**Flood Control Project Maintenance  
Levee Inspections**

## Maintenance Issue Types Only, Levee Inspection Report By Mile - Spring 2015

### Reclamation District No. 0556 Upper Andrus

Photo 1 of 1 : SP\_2015\_RD0556\_18\_26\_20150430\_00025.jpg

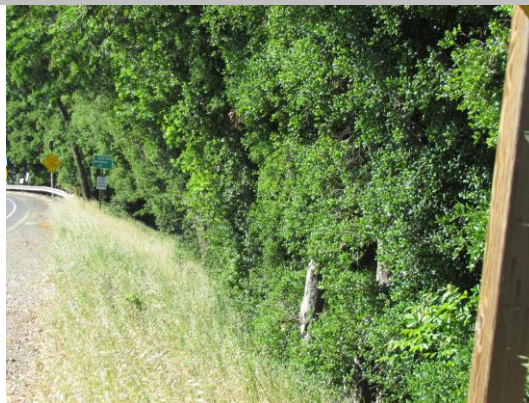
LM Start	0.22	Rating **	U	Issue No.	26
LM End	1.70	Issue Type +	Ma	Location *	LS
Category	Earthen Levee			GPS Latitude/Longitude	
				Start	End
Item	Vegetation			38.236055 °	38.224305 °
				-121.518035 °	-121.537263 °
DWR ID	DWR_RD0556_01_f_2014_26				
Action/Comments					
Trees / Woody Vegetation					
Inspector Comments: The woody tree growth blocks view of the levee slope.

Woody tree growth on the landward levee slope.

Photo 1 of 1 : SP\_2015\_RD0556\_18\_376\_20150430\_00028.jpg

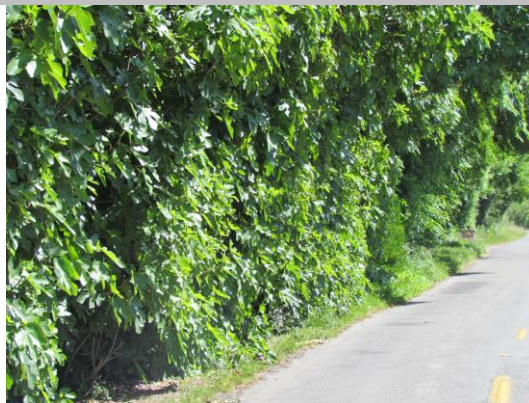
LM Start	0.62	Rating **	U	Issue No.	376
LM End	0.90	Issue Type +	Ma	Location *	LS
Category	Earthen Levee			GPS Latitude/Longitude	
				Start	End
Item	Vegetation			38.231535 °	38.228602 °
				-121.522675 °	-121.526289 °
DWR ID	DWR_RD0556_01_s_2014_376				
Action/Comments					
Trees / Woody Vegetation					
Inspector Comments: District should remove these unacceptable fig trees from the landside levee section.

Remove the fig trees on the landside shoulder and toe.
